**UNITED STATES DEPARTMENT OF COMMERCE
Patent and Trademark Office**

Office Action Summary

Application No.
09/653,169

Applicant(s)
SAKAMOTO, ET AL

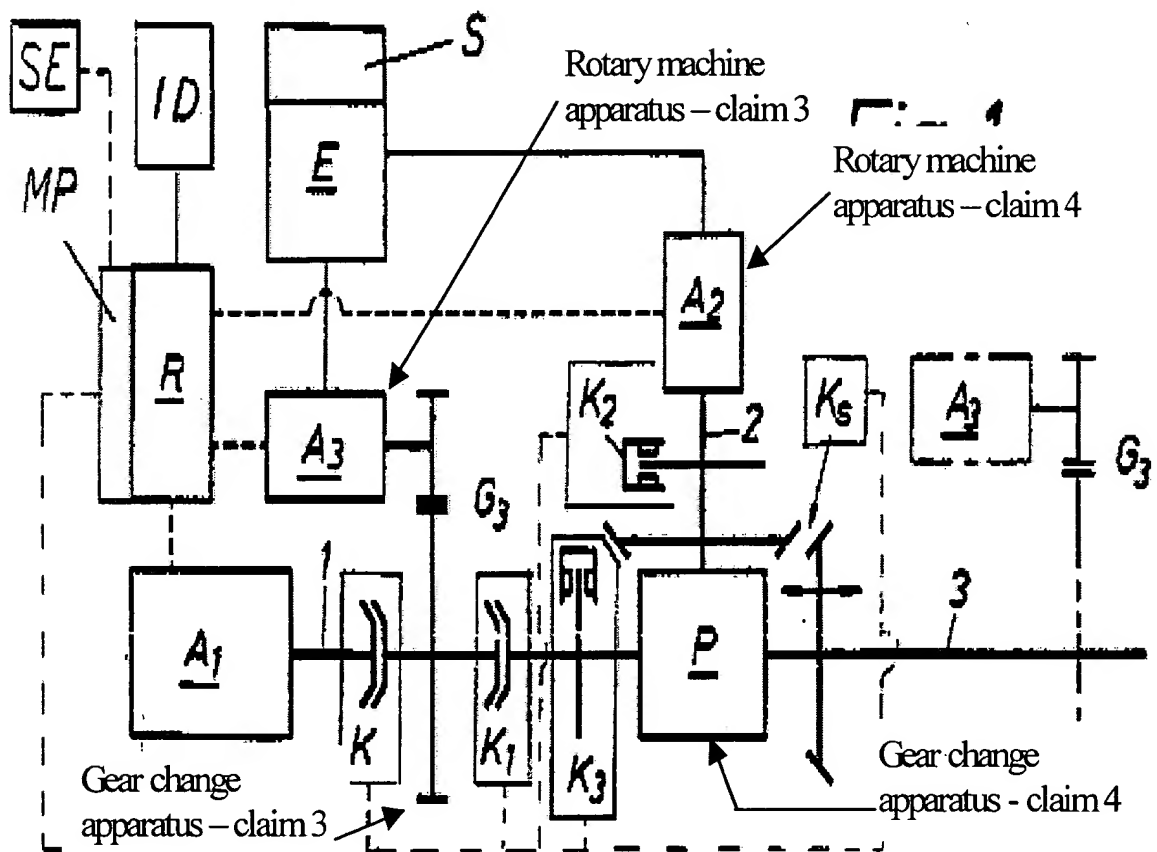
an electric rotary machine (see sketch next page and lines 38 and 39 of column 3 of Kriegler) connected to an output shaft (1) of said engine and said vehicle drive shaft via said gear change apparatus (Figure 1);

wherein a gear connected to the output shaft of said electric rotary machine meshes with a larger diameter gear in an engine side input shaft of said gear change apparatus (claim 3 - see sketch next page); and

wherein the output shafts of said engine and said electric rotary machine are provided separately (claim 4 - see Figure 1), and;

gears respectively mounted on said two shafts for transmitting the power of the output shaft of said engine and the output shaft of said electric rotary machine directly engage with each other (claim 4 - see sketch below and Figures 1 and 2 of Kriegler, noting that there is a "bevel"

gear associated with P and connected with K₃ not illustrated on Figure 1, but illustrated on Figure 2.
